Flight Procedure Tracking Form		Action: AMENDMENT	Task Type: IAP	Date Open: 10/22/2015	Task #: 2014111726683101004	Request #: 20141117266831
Procedure: APPROACH VOR A AMDT 3E			Airport ID: KOKB	Airport: BOB MAXWELL MEMORIAL AIRFIELD		Reimbursable #: NO
City: OCEANSIDE	ST: CA	GPS #:	Estimated Chart Date: 03/31/2016		FICO #:	
Fac ID: N/A		Fac. Type:			Specialist: BRYAN BLUE	
Procedure Review						
	Rec'd	Rel'd	Full Name	Comments		
Lead:	10/22/2015	11/17/2014	DANA MITCHELL			
QA:	11/17/2014	11/30/15				
Liaison:						
Procedure Comments:			Remark Type: INFORMATION			
P--NOTAM 5/1877 CONTACT: ALAN WILL/JOHNNIE BAKER, 405.954.4576/5148 Request Flight Check table bp

Project Name: OKB (OCEANSIDE MUNI, CA)

VOR-A
OCEANSIDE MUNI (OKB)

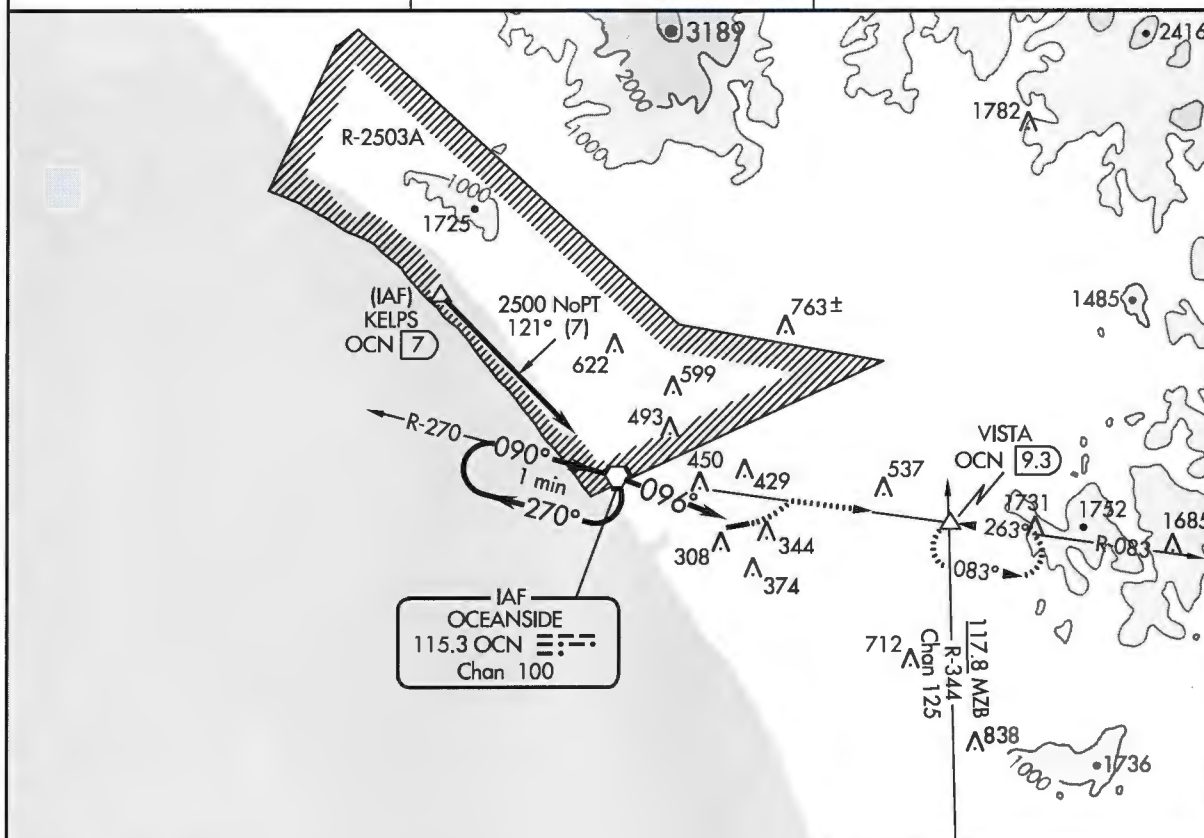
Project Reason: 20:1 PENETRATIONS STILL EXIST FOR RWY 6, KL320048 ROAD (331302.66N/1172125.33W, KL320047 ROAD (331301.65N/1172126.19W). ALSO, AIRPORT NAME CHANGED TO BOB MAXWELL MEMORIAL AIRFIELD PER NFDD 219-20 11/13/2015.

!FDC X/XXXX OKB IAP OCEANSIDE MUNI, OCEANSIDE, CA. VOR-A, AMDT 3D... CHART NOTE: HELICOPTER VISIBILITY REDUCTION BELOW 1 SM NOT AUTHORIZED. CHART NOTE: NIGHT LANDING: RWY 06 NA. CHANGE AIRPORT NAME TO READ BOB MAXWELL MEMORIAL AIRFIELD. THIS IS VOR-A, AMDT 3E.
1512292110-PERM
